# **SIGMA WAREHOUSE & DISTRIBUTION FACILITY OAKDALE SOUTH ESTATE SITE 3A - SSDA 7719**

**SECTION 4.55 (1A) MODIFICATION**

28 SEPTEMBER 2018  
MODIFICATION

PREPARED FOR SIGMA COMPANY LTD

Figure 4 – Proposed Site Plan

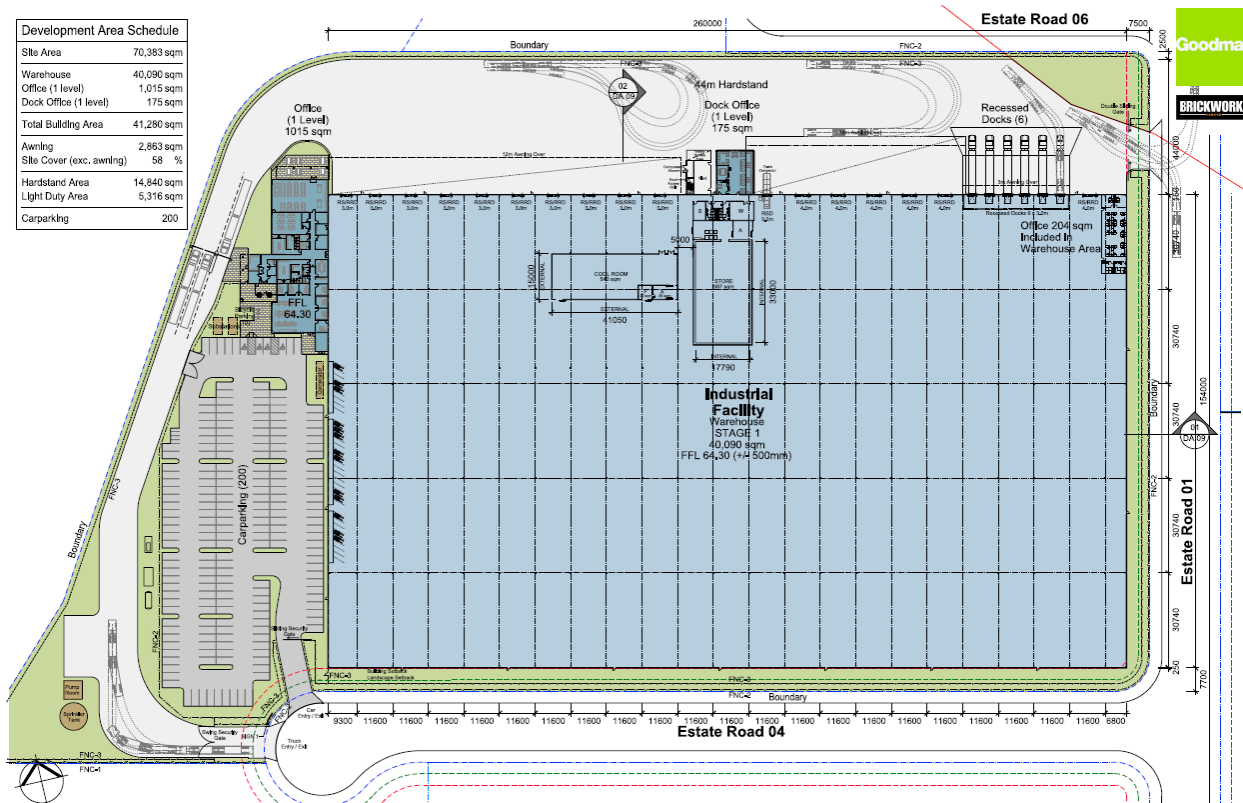
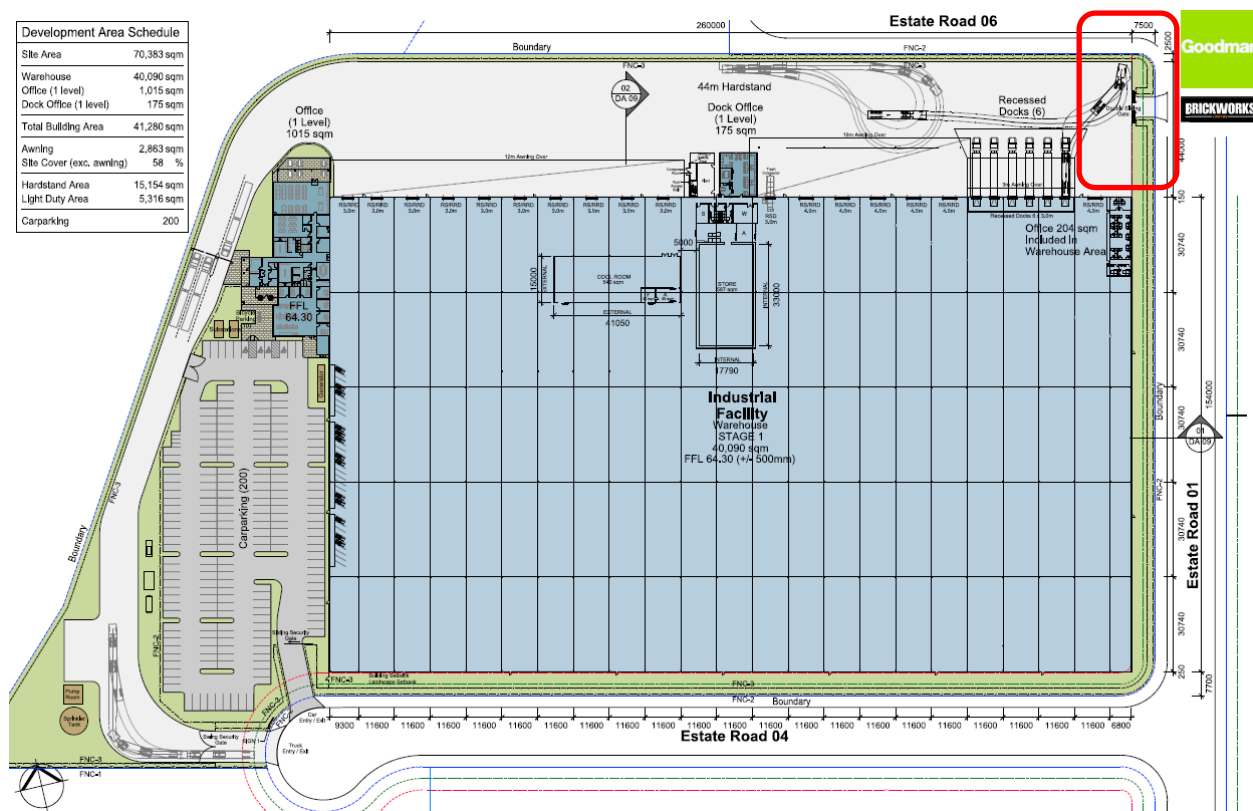
- Grading-over of the landscaped area at the north-eastern corner of the site for use as truck hardstand and turning area; and
- Relocation of the Fire Access vehicular crossing northwards towards the north-eastern corner. It is noted that the main site access/egress point for delivery truck movements will remain via Estate Road 04.

- Expansion of the grading of the hardstand area to the north-eastern corner of the site.
- Relocation of the Fire Access vehicular crossing northwards towards the north-eastern corner.

All truck access is provided from the private road consistent with the approval. The fire truck emergency access point located to the north east of the warehouse will be relocated further north towards the corner of the site.

Figure 6 – Proposed Changes to the Layout and Design

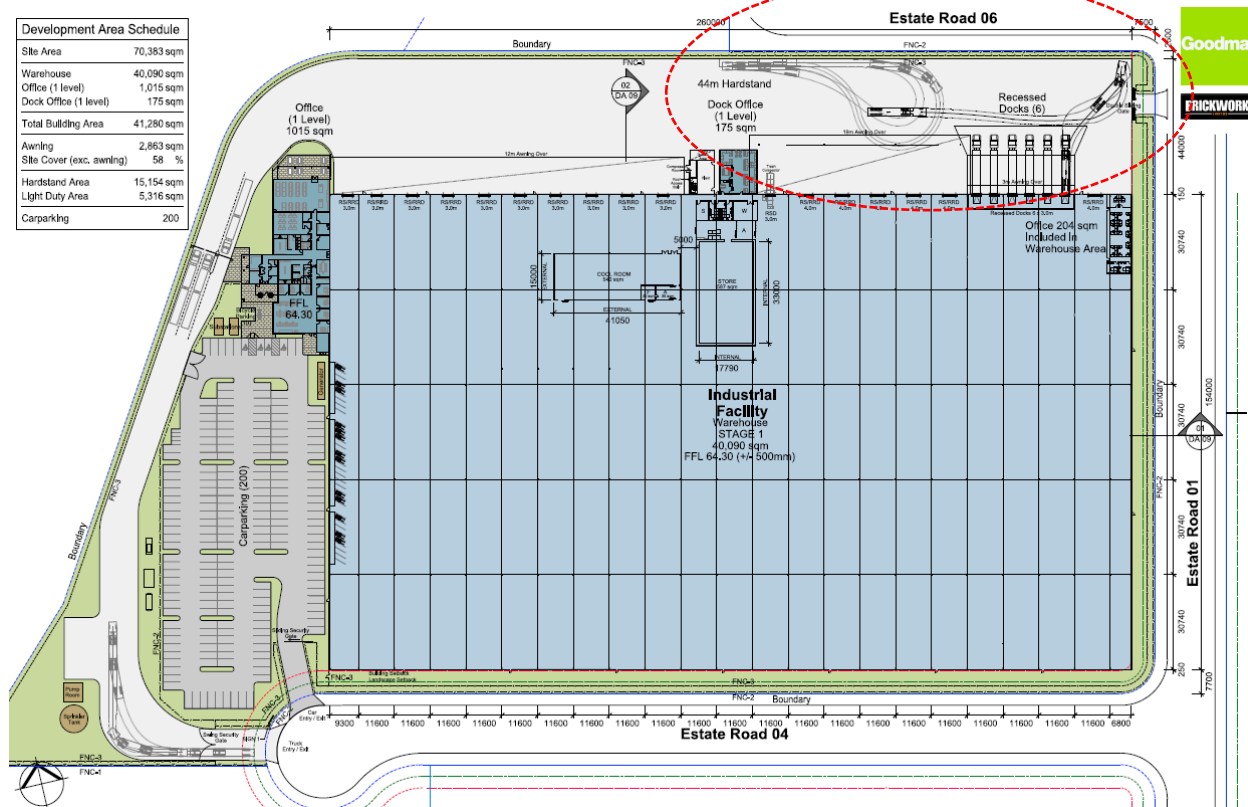
The traffic assessment undertook a swept path analysis for the site that demonstrates vehicular movements and circulation as a result of the expanded hard stand area and relocation of the vehicular crossing are acceptable. The analysis concluded that the expanded hardstand area will enable increased vehicular circulation and access to the recessed docks of the warehouse building. Figure 6 overleaf indicates the swept paths.

Figure 7 – Comparison of Landscaping at North East (NE) Corner

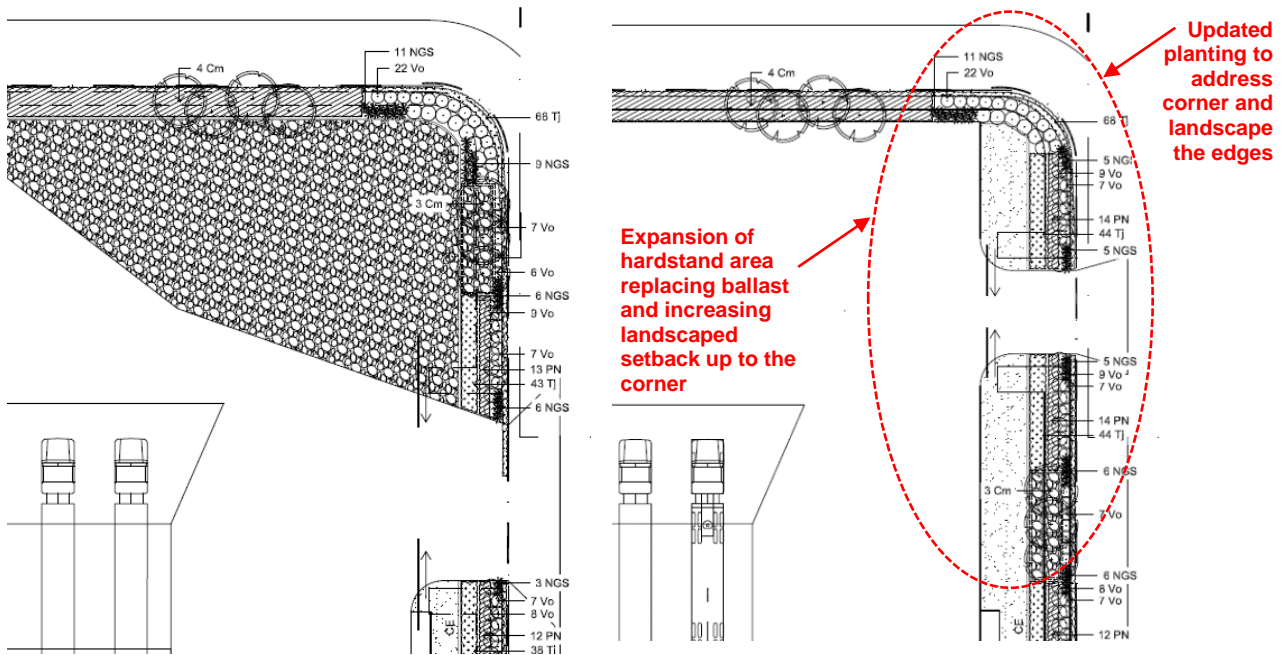
The proposed modification to the north-eastern corner will require the reduction and replacement of the ballast (gravel) covered area that previously responded to the existing riparian corridor zoned E2 – *Environmental Conservation*. It is noted that part of the site is now zoned IN2 Light Industrial. The proposal will involve further reconfiguration due to the relocation of the Fire Access further north (closer to the corner). The main components of the landscaping scheme are listed as follows:

- The corner will be planted with a mix of grasses and hedges which address the corner element and edges.
- Grading of the hardstand area is expanded and squared off to enable truck turning and access. The eastern edge of the hardstand area will be landscaped with a turfed setback and layered planting matching the landscaped setback along the eastern edge of the site.

The amendments to the north-eastern corner enable an increase in turf and soft landscaping. This is achieved by extending the landscaped setback up to the corner element. The landscaped setback provides turf and layered planting along the edge of the expanded hardstand area. The hardstand replaces the ballast (gravel) cover that was approved as part of SSD7719, and increases the area for truck usage.
